# Initial Project Review

## Non-Conforming Use Permit: Franklin Pierce School District Performing Arts Center

**Application Numbers: 951591**  
**Parcel Numbers: 0319034000**

**Proposal:** Construct a new 18,000-square foot Performing Arts Center (PAC) that will be connected to the existing Franklin Pierce High School (FPHS) main building.

## Site Plan

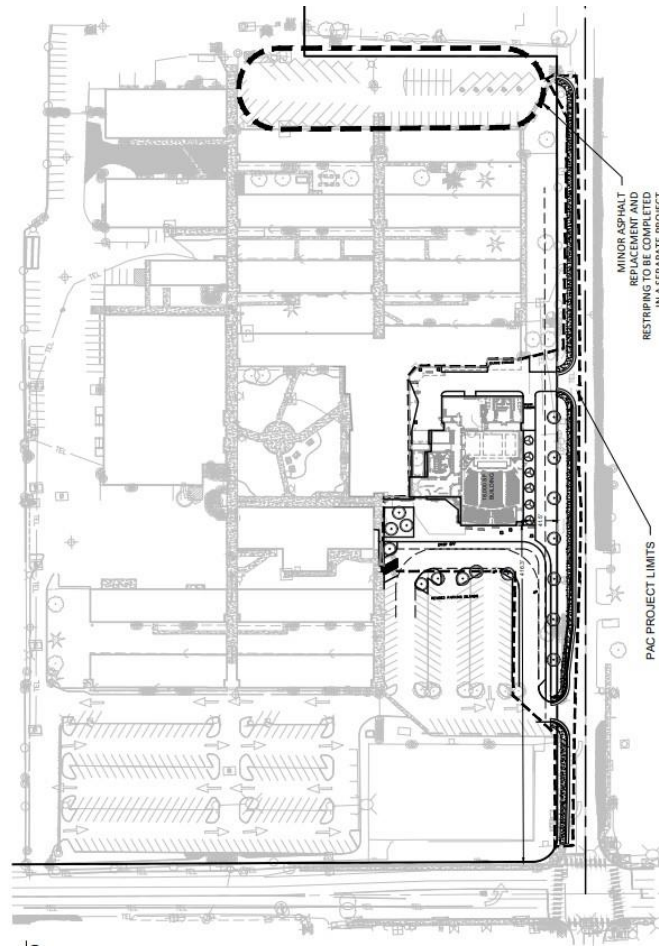
*Staff Comment:* The addition of the PAC would not change enrollment or school capacity for the proposed improvements. The existing parking is approximately 485 spaces and the new PAC facility will eliminate up to 95 parking spaces, resulting in a total number of available parking of approximately 390 spaces. The estimated parking is within the required parking range of roughly 250 to 485 spaces, meeting the intent of this section.

*Staff Comment:* A Level 1 landscape buffer is required along the roadway frontage of 18<sup>th</sup> Avenue East. The proposed landscaping meets or exceeds this requirement.

*Staff Comment:* The new buildings and parking areas will be required to meet the exterior illumination requirements. The proposed lighting for the new facility exceeds this requirement due to the school's need for visibility and safety.
